Class Rule Changes

International KiteFoil Open Class Association

Effective date: 09 Mar 2023

Status: Approved

C.6.2 Placement of Advertising and Class Insignia

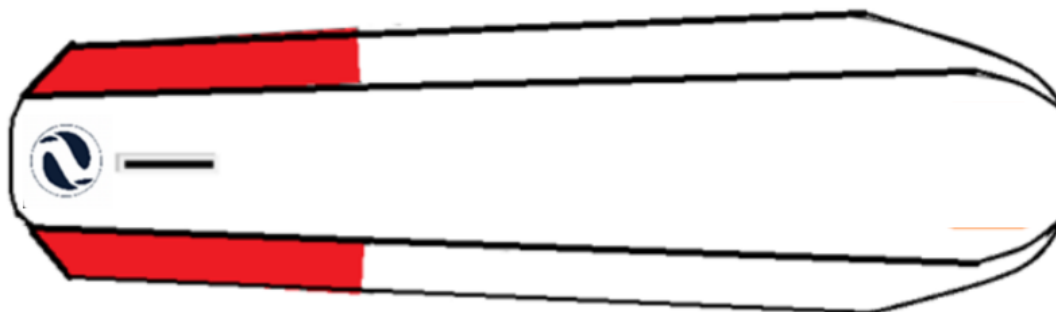
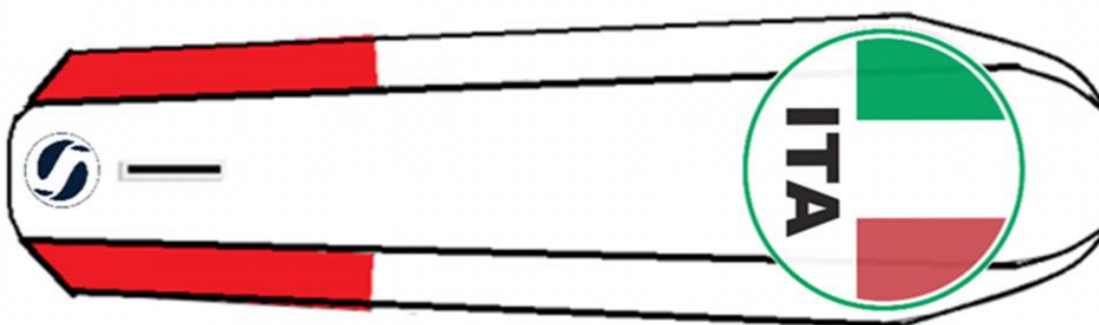
Amendment Six

C.6 ADVERTISING

The areas on each sides of the rear 30% of the bottom of the hull, are reserved for event advertising within an area of 50x10cm. The class insignia shall be placed on the bottom of the hull, centered behind the mast box / mast track, within an area of 10x10cm, and shall not be trimmed, cut, or covered by other materials.

Aft Red: Event Advertising

Rename C.6.2 to 'Placement of Advertising' and delete the last sentence of C.6.2

C.6.2 Placement of Advertising

The areas on each sides of the rear 30% of the bottom of the hull, are reserved for event advertising within an area of 50x10cm.

Aft Red Area: Event Advertising
